## Thurlow Road

# ROOF AMENDMENTS 30/05/2019

Flat 4, 20 Thurlow Rd, London NW3 5PP

### **COMMENTS FROM NORA**

### PROPOSED ELEVATION

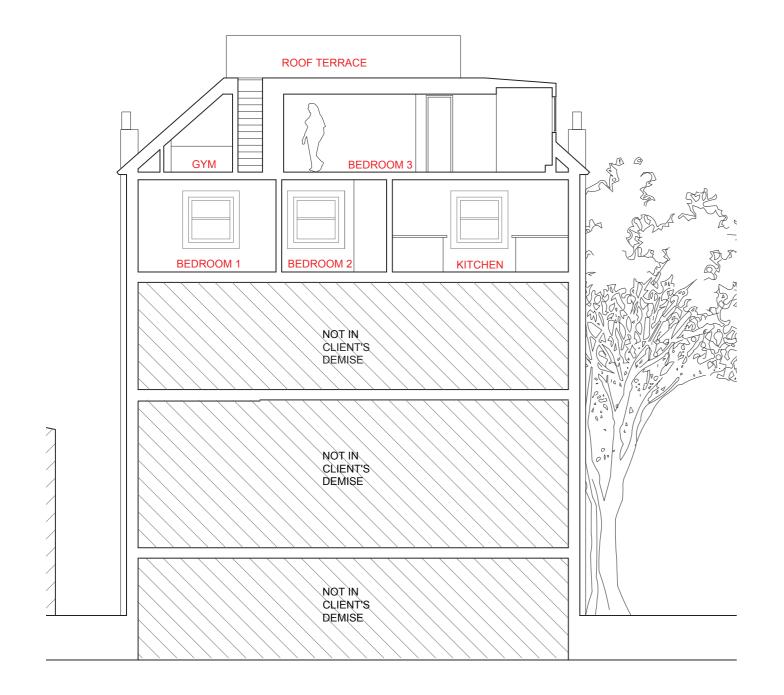
As the ridge is increased and the overall roof volume, the dimensions of the dormers should remain the same as in option A. There would be sufficient internal height (up to 2.3m) to allow the dormers to be further set down from the ridge, and up from the eaves in order to be proportionate to the roof slope they sit within. Currently they look too stretched out and bulky. Please clarify what materials you are proposing for the dormers.

In the drawings for option B, the increase in ridge height seemed to enlarge the other elements of the roof too – the chimney breasts are higher. These should remain the same as existing. In relation to this, please explain how you envisage the construction works would take place around the chimney breasts, in order to ensure they will be retained and protected.

The proportions of the dormers have been changed as requested and were set down from the ridgeline by 350mm.

The chimney breasts will remain as they are.

Ridge height increased by 400mm while eaves remain as they are.

# ROOF DETAIL A - BAY WINDOW ON NORTH ELEVATION ROOF LIFTING

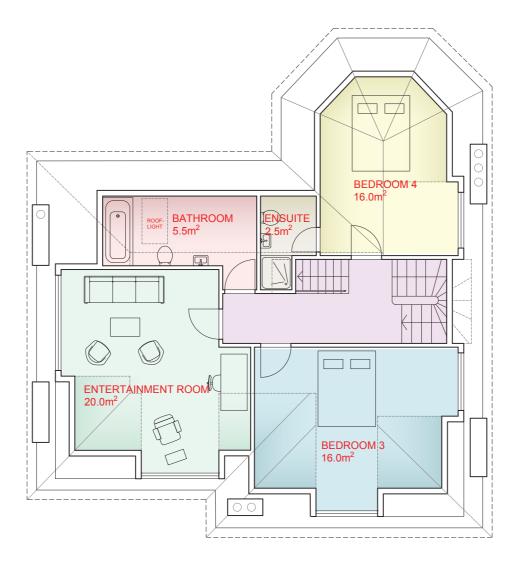
Please provide detailed drawings of how the front bay roof would meet the new ridge. As I said before we need a bit more detailed drawings overall to ensure the proposal is actually feasible.

See Detail A - p7
